# Near-term Task Force Recommendation 2.1 Seismic Hazard Evaluation

## Salem Nuclear Generating Station

June 12, 2014

# **Salem Generating Station (SGS)**

# Amplification Functions

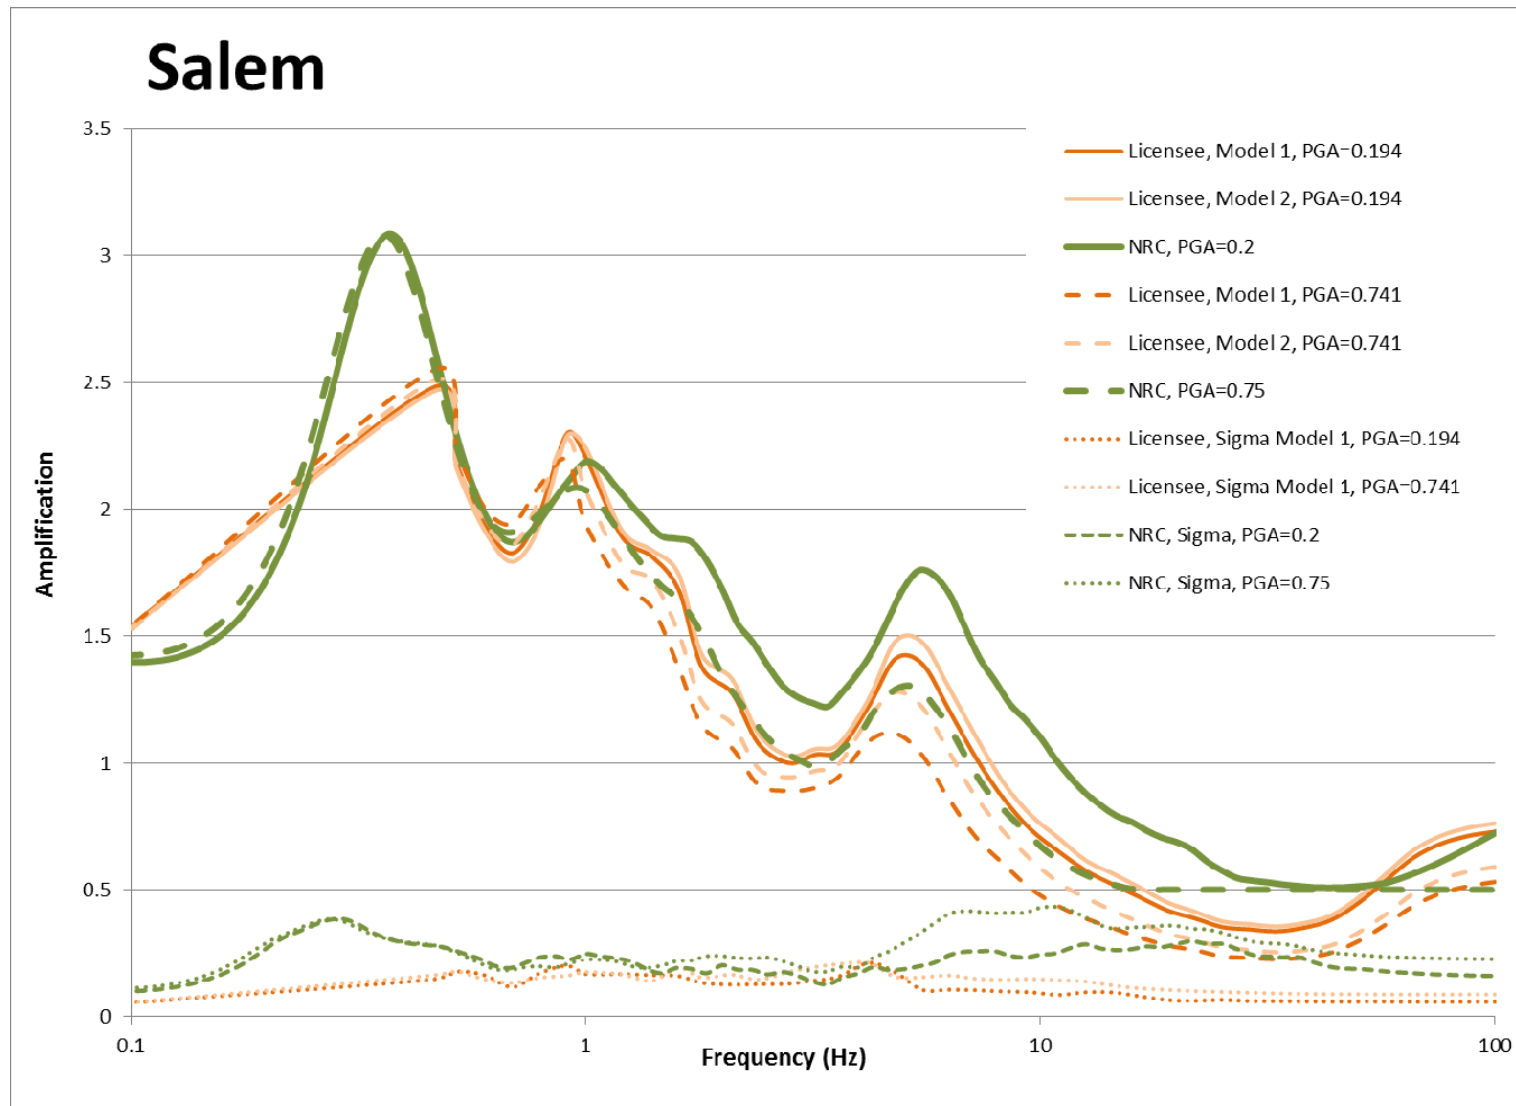
# Primary Differences

- Different treatment of damping for Potomac Group Formation
- Licensee determined a total kappa value of 0.037
- NRC calculations produce a total kappa of 0.015
- Licensee used 3 base case profiles vs 1 for NRC
